Access Compliance Report

Public Rights-of-Way

(Curb Ramps)

Intersection ID: 50589	Main Street: BENDING_BRANCH_RD	Cross Street: GREEN_GRASS_RD	Location: S
ADA ID: 92339C22A6F6	Ramp Type: BlendTrans1	Initial Pass/Fail: Fail	Overall Compliance: No
Severity Score: 8.75			
Codes/Mitigation Info/Possible Solution		Field Measurements/Component Compliance

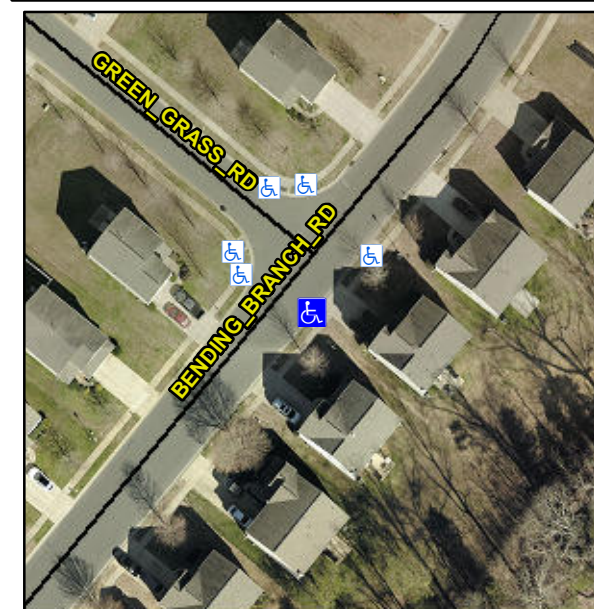
Not Found, R304.5.1

Compliance	Description	Data	Compliance	Description	Data
N/A	Ramp Length (in)	48.0	Yes	BlendTrans Slope (%)	3.9
No	Ramp Width (in)	47.5	Yes	BlendTrans XSlope (%)	1.2
N/A	Flare Type LT	N/A	N/A	Flare Type RT	N/A
N/A	Flare Slope LT (%)	N/A	N/A	Flare Slope RT (%)	N/A
N/A	Flare Traversable LT?	N/A	N/A	Flare Traversable RT?	N/A
N/A	Landing Length (in)	N/A	N/A	DWS Provided?	N/A
N/A	Landing Width (in)	N/A	N/A	DWS Contrast?	N/A
N/A	Landing Slope (%)	N/A	N/A	DWS Length (in)	N/A
N/A	Landing X Slope (%)	N/A	N/A	DWS Full Width?	N/A
N/A	Landing Curb? (Y/N)	N/A	N/A	DWS Offset (in)	N/A
N/A	Shared Landing?	N/A			
N/A	Gutter Ponding?	N/A	N/A	Gutter Slope (%)	N/A
N/A	Gutter Lip Ht (in)	N/A	N/A	Gutter X Slope (%)	N/A
N/A	Painted X Walk1?	No	N/A	Painted X Walk2?	N/A
	X Walk 1 Direction	To NW		X Walk 2 Direction	N/A
	X Walk 1 Width (in)	N/A		X Walk 2 Width (in)	N/A
	X Walk 1 Slope (%)	1.4		X Walk 2 Slope (%)	N/A
	X Walk 1 X Slope (%)	2.3		X Walk 2 X Slope (%)	N/A

N/A	Ramp inside XWalk1?	N/A	N/A	Ramp inside XWalk2?	N/A
	Road Slope (%)	2.3		Clear Space?	N/A
	Road X Slope (%)	1.4	N/A	Clear Space to XWalk (in)	N/A
N/A	Any Obstructions?	N/A	N/A	Storm Grate/Utility Hazard?	N/A
	Obstruction Type			Storm Grate/Utility Type	
		N/A			N/A
			Yes	Surface Condition? (G/P)	Good
			No	Curb Slope (%)	7.5

Remove & Replace Curb Ramp With Two New Directional Ramps or Equivalent.
